DART AEROSPACE LTD
HAWKESBURY, ONTARIO, CANADA

DRAWING NO. REV. C
D3290 SHEET 1 OF 2
TITLE SCALE
REPLACEMENT WINDOW ASSEMBLY 1:5

DRAWING NO. D3290	TITLE REPLACEMENT WINDOW ASSEMBLY	REV. C	DART AEROSPACE LTD ENGINEERING ORDER		D.E.O. NO. D3290-C-1	SHEET NO. SHEET 1 OF 1	SCALE NTS
DRAWN 90	CHECKED 16	MFG. APPR. E	APPROVED MD		DE APPR. 11		
DATE 09.09.18	DATE 09.09.18	DATE 09.09.18	DATE 09/09/21		DATE 09/09/21

CHANGE MATERIAL THICKNESS OF D3290-1 FRAME TO 0.063 FROM 0.040. REF PAR 09-033.

D3290-1 FRAME

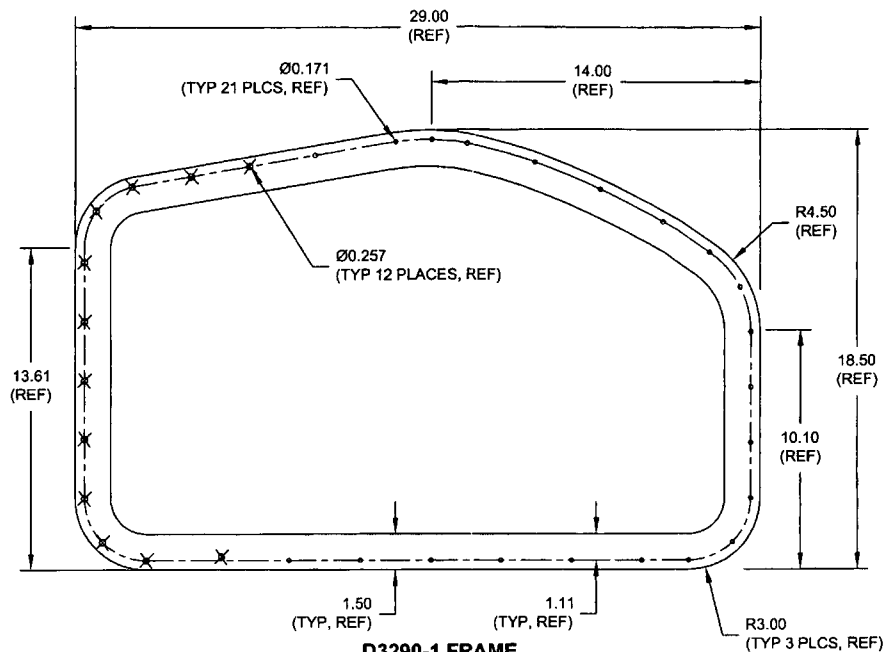
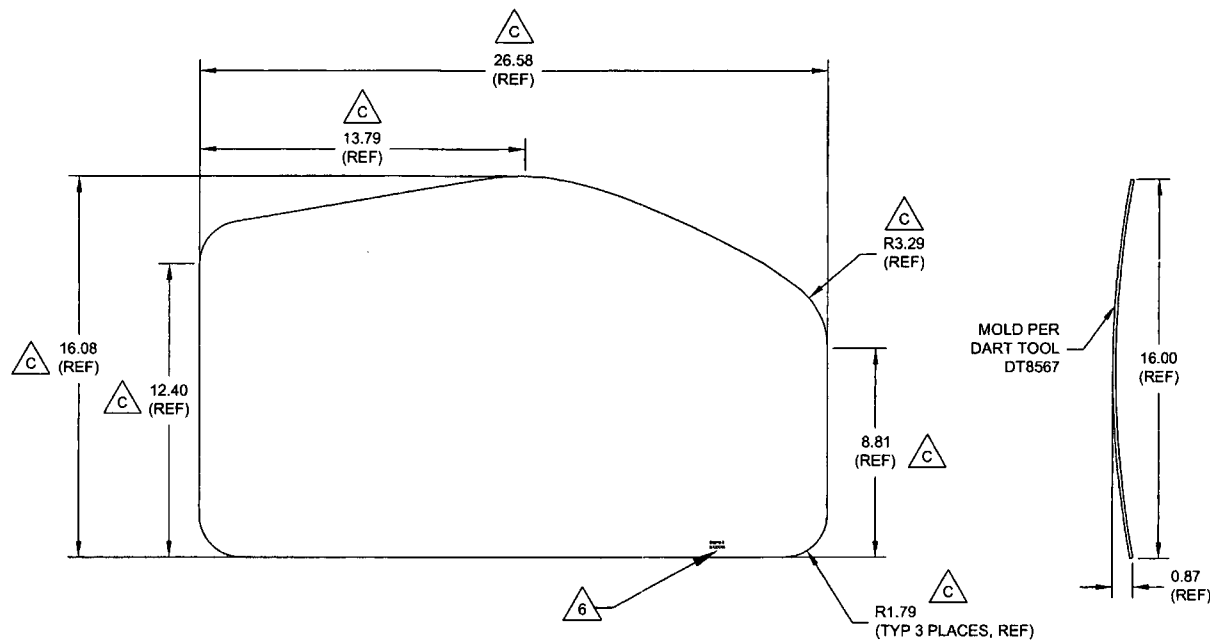
MATERIAL CALL-OUT OF D3290-1 FRAME ON SHEET 1 IS AMENDED AS FOLLOWS:

- 1) MATERIAL: 6061-T6 (OR 6061-T62) ALUMINUM SHEET ~~0.040 THICK~~ 0.063 THICK (REPLACE)
 PER AMS-QQ-A-250/11 OR AMS 4025 OR AMS 4027
~~(REF. DART SPEC. M6061T6S.040)~~ REF. DART SPEC. M6061T6S.063 (REPLACE)
 OR
 5052-H32 ALUMINUM SHEET ~~0.040 THICK~~ 0.063 THICK (REPLACE)
 PER AMS-QQ-A-250/8 OR AMS 4016
~~(REF. DART SPEC. M5052H32S.040)~~ REF. DART SPEC. M5052H32S.063 (REPLACE)
